Proposal for IEEE 802.16m SDD Text on Bandwidth Request/Renewal Channel

Document Number: IEEE C802.16m-08/1076

Date Submitted: 2008-09-05

Purpose: Adopt the proposal into the IEEE 802.16m System Description Document

Figure 35 Bandwidth Request Procedure

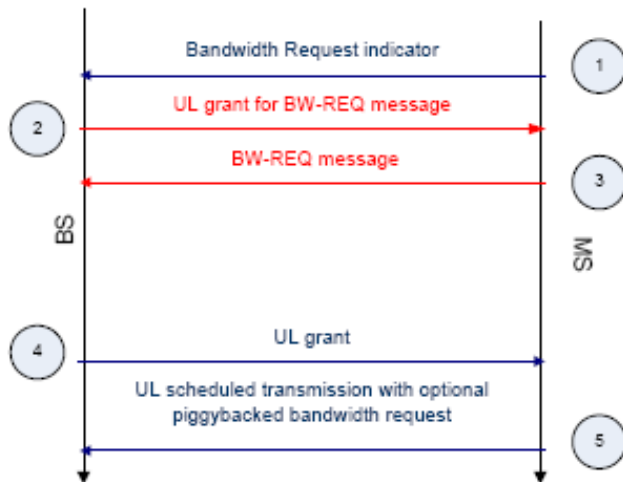
- Current SDD text supports quick access procedure where BW indicator is sent, followed by UL grant
- SDD text does not define message parameters or response from BS

Contention based or non-contention based random access is used to transmit a bandwidth request indicator on this control channel. To support different levels of QoS, the bandwidth request channel provides a mechanism for prioritized bandwidth requests. *[sentence relocated]*

The mobile can choose the whether to use the bandwidth request/renewal indicator over designated resources or send a bandwidth request over UL fast feedback channel.

An MS is assigned a unique bandwidth request/renewal indicator ID so that the MS may be identified upon reception of the request. In order to limit the overhead of this channel, the bandwidth request/renewal indicator does not carry other information. Upon reception of the request, the BS sends a UL grant according to a predefined service configuration (such as VoIP) or default allocation if none has been defined.

A bandwidth request can also be sent over the UL fast feedback channel. The bandwidth request can be sent in place of another UL feedback field such as CQI. The message type field of the UL fast feedback channel can indicate that a bandwidth request is being sent instead of a different feedback. Inclusion of additional information in a bandwidth request indicator such as bandwidth request size, MS-ID, flow identifier, uplink transmit power report and CINR report is FFS.

The random access bandwidth request procedure is described in Figure 35. A 5-step regular procedure (step 1 to 5) or an optional quick access procedure (step 1,4 and 5) may be supported concurrently. Step 2 and 3 are used only in 5-step regular procedure. In step 1, MS sends a bandwidth request indicator that may indicate information such as MS addressing and/or request size (FFS) and/or uplink transmit power report (FFS), and the BS may allocate uplink grant based on certain policy. The 5-step regular procedure is used independently or as fallback mode for quick access procedure. The MS may piggyback additional BW-REQ information along with user data during uplink transmission (step 5).
